CITY AIRPORT DEVELOPMENT PROGRAMME (CADP)

**ENVIRONMENTAL STATEMENT
SECOND ADDENDUM (ESSA)
AND OTHER CLARIFYING
INFORMATION**

28 May 2014

London Borough of Newham's Regulation 22 Letter, 23rd May 2014

A9575_N10 - London City Airport - Construction Noise Contour 01

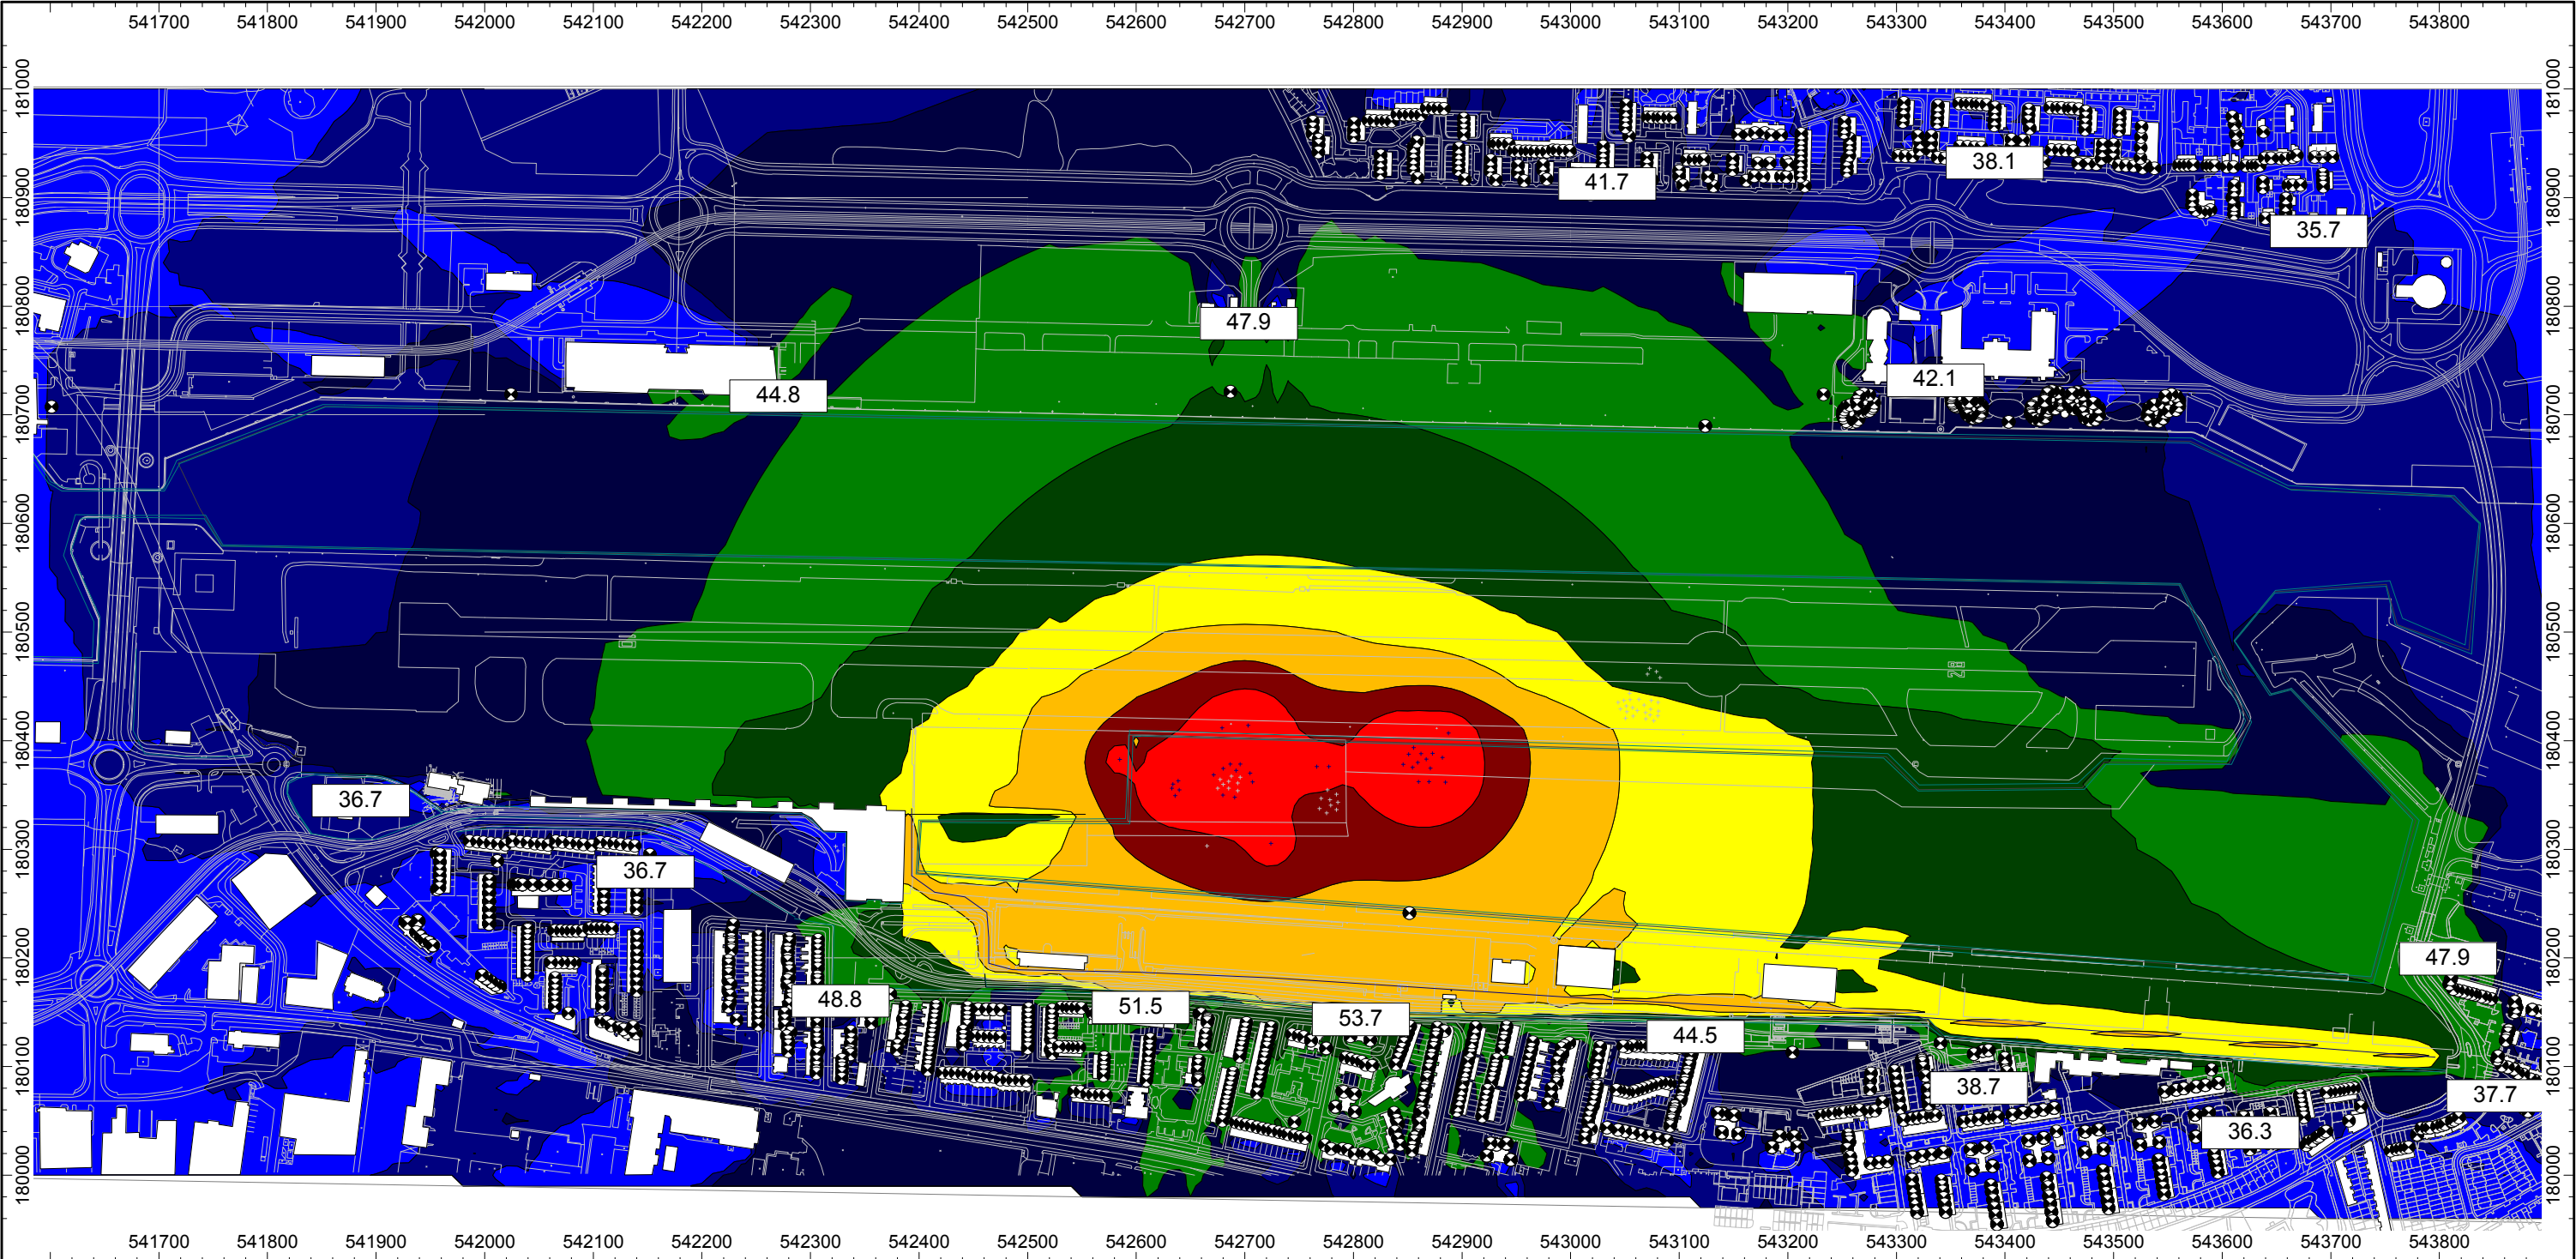
3) In the case of the 15-minute night-time criterion, and over shorter periods, noise levels are likely to be attributable to specific activities and the operation of specific plant rather than an average as per the calculations. For example, an on-time of 10% attributable to a 12-hour day is around 80 minutes.

On this basis, it is entirely possible for plant to be operating fully over a period of 15-minutes. The use of 'on-time' weighted assessed noise levels is not a suitable method of assessment for night-time 15-minute limits and therefore does not provide a sufficient understanding of the significance during the night.

The assessment should therefore be refined to provide further information of the sensitivity of these on-time assumptions on 15-minute night-time construction noise levels.

- 3.17 **Contour 1** – This is the same contour as produced in the Appendix 3.3 of the ESA for the “Night Deck Construction Activity” in July 2016 for reference purposes. The figure has been updated to present a worst case 1 hour noise level. This includes 6 work areas; 1- Deck Section 2A (pile heads and beams), 2- Deck Section 2A (deck planks services and toppings), 3- Eastern terminal stand extension services, 4 -Deck Section 3A (piles), 5- Deck Section 3A (pile heads and beams) and 6- Noise Barrier works. An explanation of these work sections is provided in Appendix 3.1 of the ESA with the locations identified in Appendix 3.2 of the ESSA. In practice it is very unlikely that simultaneous work will be happening in all 6 work areas during the same hour and these levels are likely to be over-predicting the 1 hour construction noise level.
